Hip Bone Creek Baseline Monitoring Report

Hip Bone Creek Restoration Site
Cape Fear River Basin - 03030003
Monitoring Year 00
DMS Contract 7528
DMS Project Number 100059

MEMORANDUM

Subject: Hip Bone Creek Mitigation Site
MY-00 Baseline Monitoring Report Comments
Cape Fear River Basin CU 03030003
NCDMS Project # 100059
Contract # 7528

BOUNDARY MARKING PLAN

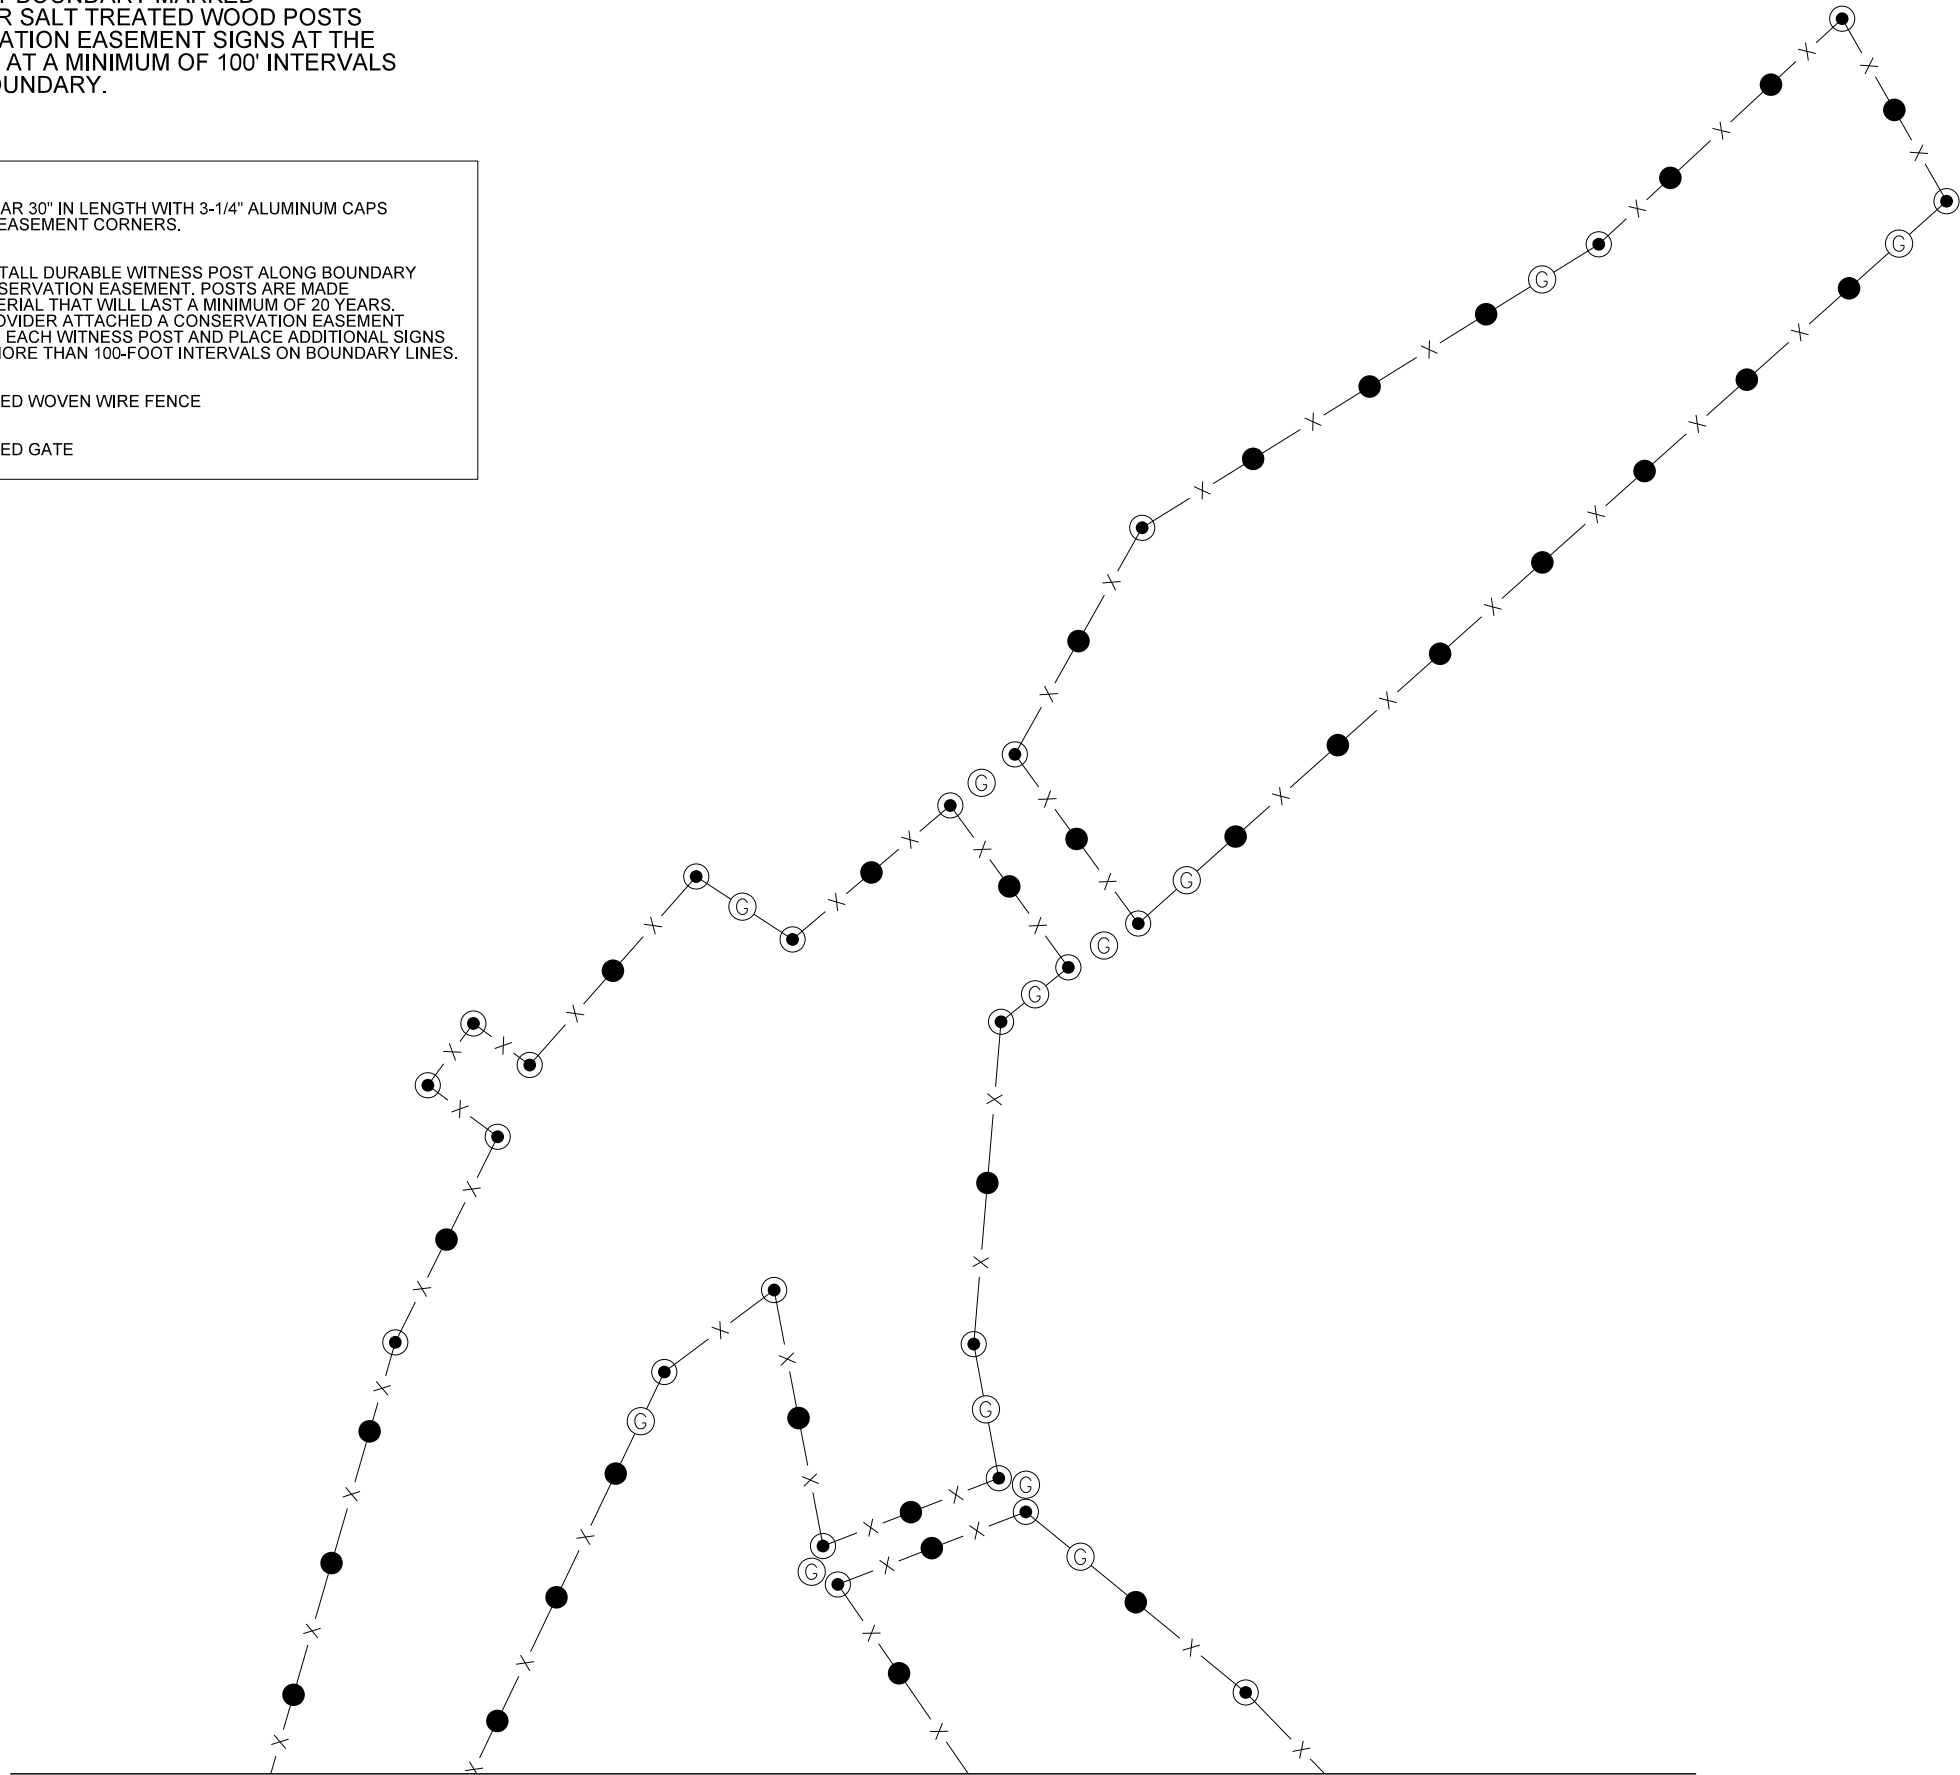
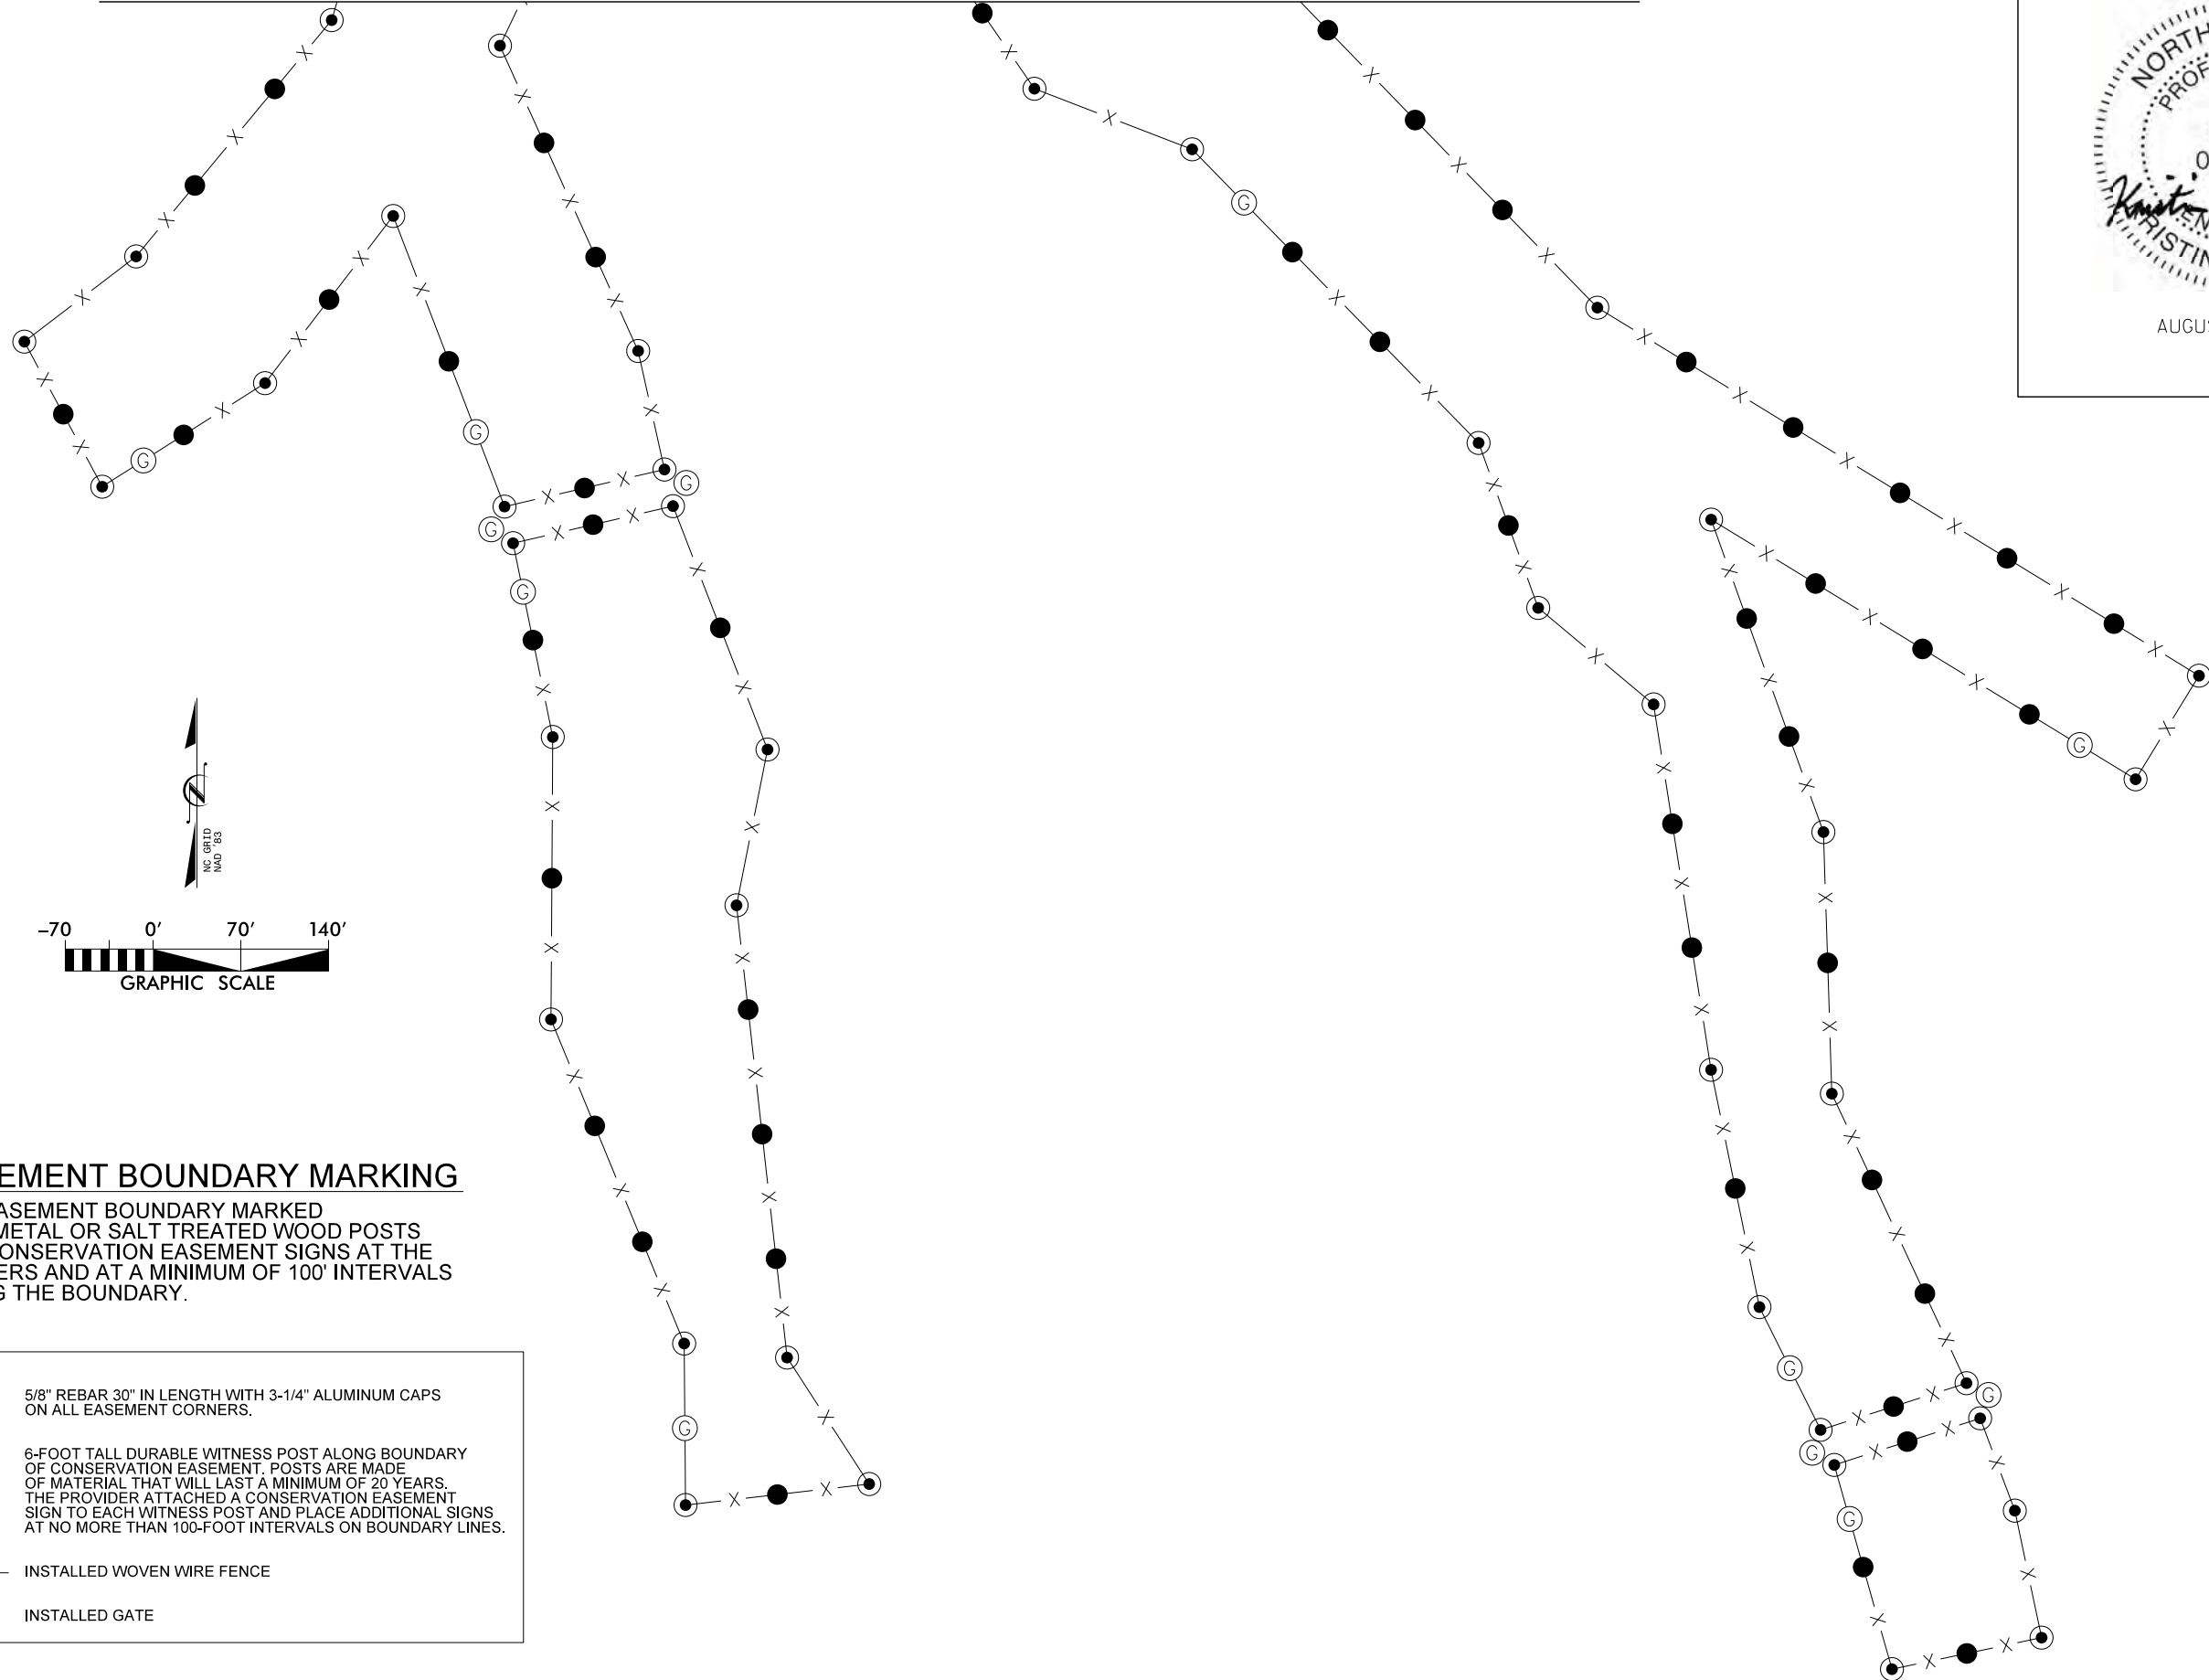
- Sheet 10 & 11 – Please update the Boundary Marking Plan sheets to show that fencing was not constructed at numerous crossings. These changes should be called out in red as deviations from design.
KCI Response: The interiors of the crossings were not fenced during DMS’s site visit on August 13 because KCI’s fencing subcontractor is waiting for the necessary material to arrive. Once this material arrives, the fencing will be installed as soon as possible. In the meantime the landowner has agreed not to move cattle through these crossings.
